Our Reference: VA101-1/18-A.01
Continuity Nbr.: VA07-01853

Re: Mount Polley Stage 6 TSF Design

This letter is in response to comments by Mr. Chris Carr who has requested the following information before proceeding with the permit conditions for the Stage 6 embankment raise for the Tailings Storage Facility at Mount Polley Mine. Mr. Carr's comments and responses from Knight Piésold are as follows:

MOUNT POLLEY MINING CORPORATION	
MOUNT POLLEY MINE	
TAILINGS STORAGE FACILITY MAIN EMBANKMENT STABILITY SECTION	
<i>Knight Piésold</i> CONSULTING	PROJECT / ASSIGNMENT NO. VA 101-1/18
	REF NO. VA07-01853
FIGURE 1	
REV. 0

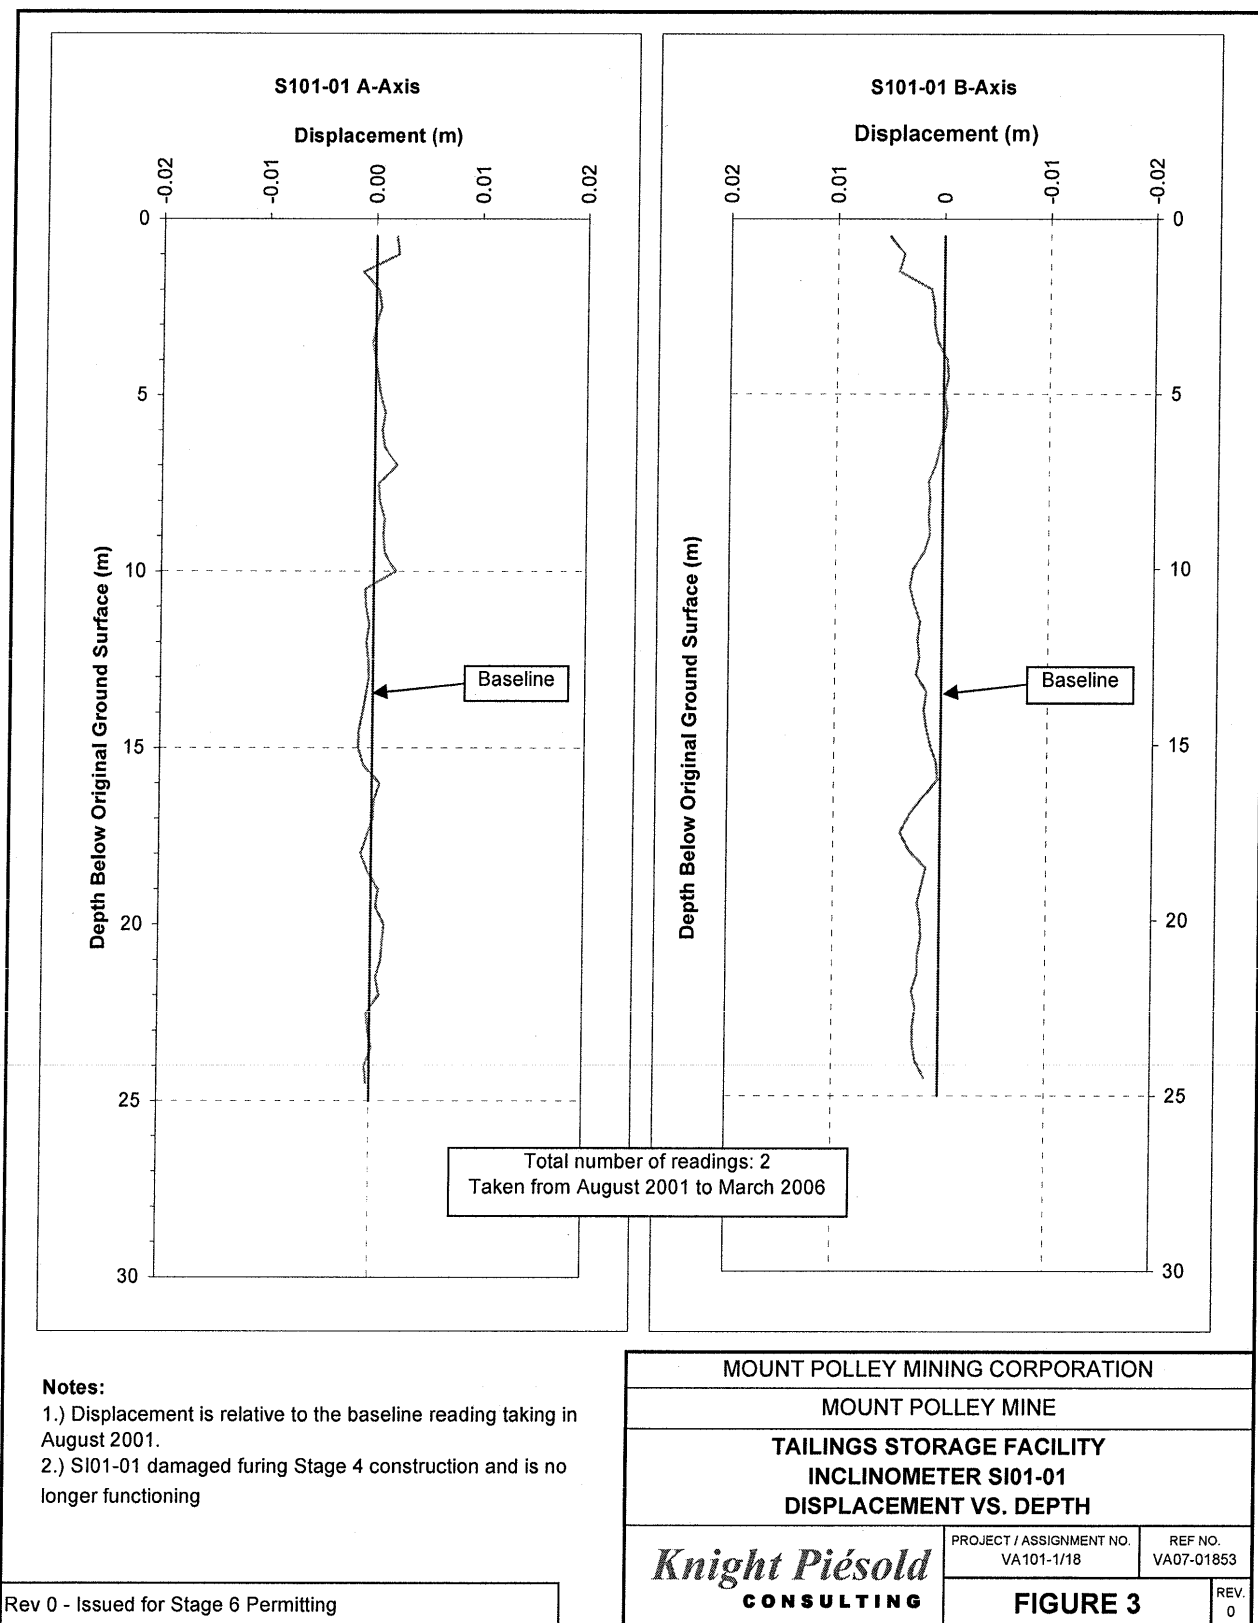
Provide cross-sections showing stability analyses for dam raise to elevation 958 m.

The cross-section used for the stability analysis for the Main Embankment is shown on Figure 1. The cross-section includes the following:

- The embankment crest was modelled with an embankment elevation of 958 m,
- The downstream buttress was modelled at an elevation of 925 m. The current elevation of the downstream buttress is 917 m. The Stage 6 construction program involves raising the elevation of the buttress to elevation 925 m to ensure that the required Factor of Safety is achieved for the Stage 6 embankment configuration.

- The lacustrine unit at the Main Embankment was modelled with a thickness of 12 m. A study comparing the drained residual strength to the clay content, liquid limit, and effective normal stress was completed by Stark and Eid (1995). The results of the study indicate that the drained residual strength of a material with a clay content ranging from 25 to 50%, with a liquid of 40%, and an effective normal stress of 700 kPa is in the order of 24 degrees. A conservative friction angle of 24 degrees was applied for the lacustrine unit. Subsequent direct shear tests conducted by Knight Piésold also indicate that the peak friction angle of the lacustrine unit is in the range of 21 to 25 degrees, (average of 23 degrees). The average residual friction angle at 20% strain was 22 degrees.

- The stability analysis was completed with the elevated pore pressures in the lacustrine unit (approximately 2.5m above ground) as the piezometers installed in the lacustrine material indicate slight artesian conditions within this material.

The results of the stability analyses indicate that the factor of safety for the Stage 6 TSF Main Embankment for static conditions was approximately 1.48 for a lacustrine friction angle of 24 degrees. A sensitivity stability analysis was also completed using different friction angles for the lacustrine unit. The results of the sensitivity stability analysis are shown on Figure 2. The factor of safety was approximately 1.44 for a friction angle of 23 degrees, the average friction angle from the direct shear tests on the lacustrine unit. The factor of safety for the lower end direct shear test friction angle of 21 degrees was approximately 1.35. The sensitivity analysis also demonstrates that the embankment would remain stable with a factor of safety greater than 1.1 for an extreme lower bound residual friction angle of 15 degrees for the lacustrine unit.

PROJECT / ASSIGNMENT NO.
VA101-1/18REF NO.
VA07-01853**FIGURE 4**REV.
0

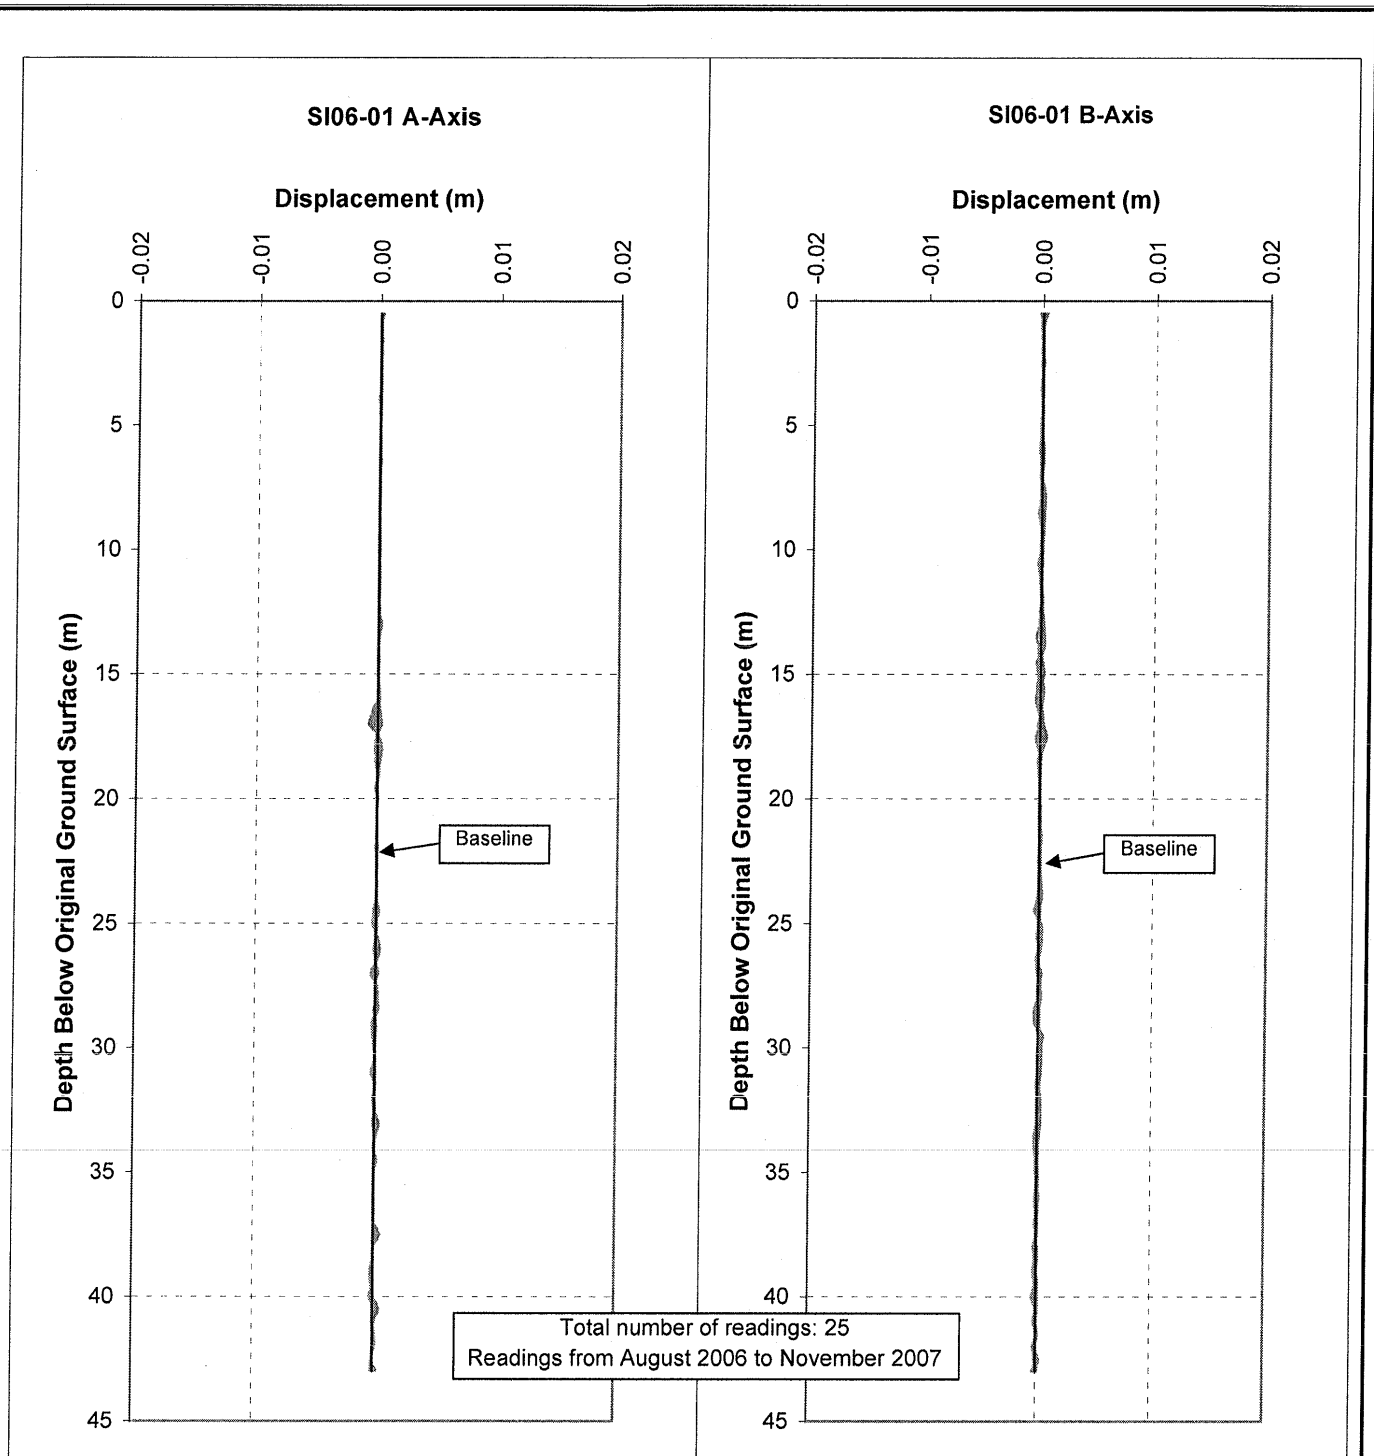
Provide slope inclinometer depth vs. cumulative displacement plots showing cumulative displacement from date of installation.

The results of the inclinometer readings indicate that there have not been any significant deviations measured in the inclinometers since their installation. There were no measurable deformations recorded

in the inclinometers during or after the Stage 5 construction program. The results of the readings for inclinometers are shown on Figures 3 to 7.
